UNITED STATES PATENT AND TRADEMARK OFFICE

APPLICATION NO.	FILING DATE	FIRST NAMED INVENTOR	ATTORNEY DOCKET NO.	CONFIRMATION NO.
10/515,980	07/06/2005	Hideaki Watanabe	101136-00120	2588
4372	7590	07/28/2006	EXAMINER	
ARENT FOX PLLC 1050 CONNECTICUT AVENUE, N.W. SUITE 400 WASHINGTON, DC 20036			PILKINGTON, JAMES	
			ART UNIT	PAPER NUMBER
			3682

Office Action Summary	Application No.		Applicant(s)	
	10/515,980		WATANABE ET AL.	
	Examiner		Art Unit	
	James Pilkington		3682

DETAILED ACTION

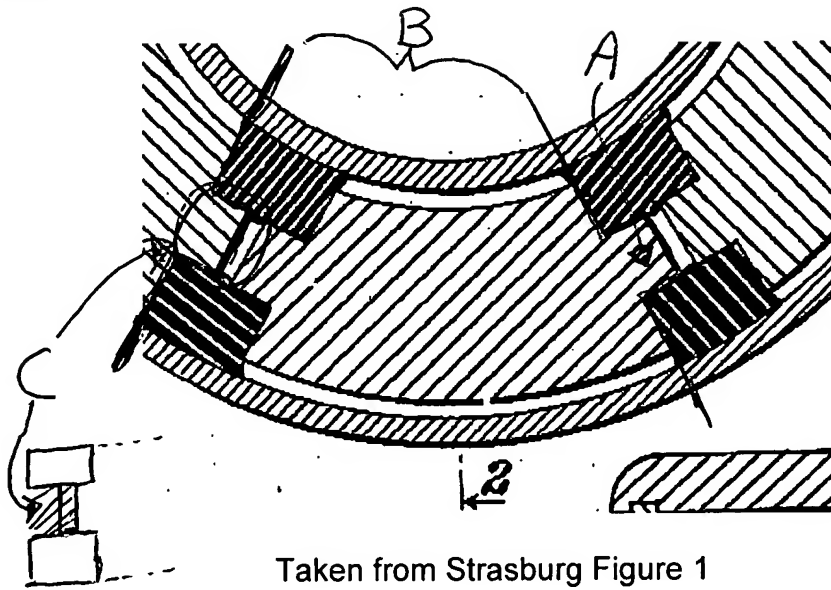
Re clm 3, Strasburg discloses a protruding piece (A, see Figure below) formed in one end of the ring piece (B, combination of 10 and 11) and a hole formed in the other end (C) of the ring piece (B), and said ring pieces are bonded in a circumferential direction by close-fitting the protruding piece (A) of one of the ring pieces (B) adjacent in a circumferential direction into the hole of the other one of the adjacent ring pieces.

Taken from Figure 3 of Tresselt

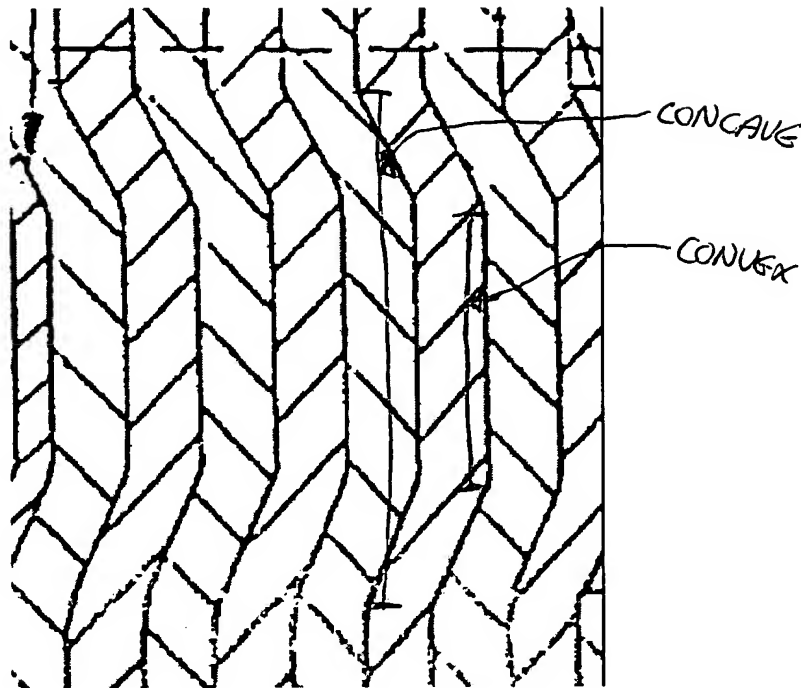
Re clm 6, Tresselt discloses dowels (66) protruded from one surface of said ring piece to the other surface are formed, and said ring pieces are bonded in a width direction (see Figure 3) by overlaying said ring pieces adjacent in a width direction so that the dowels are displaced in a circumferential direction and pressing them.

Re clm 7, Tresselt discloses the convex portion of the dowel is narrower than a concave portion (see Figure 1 inserted below).
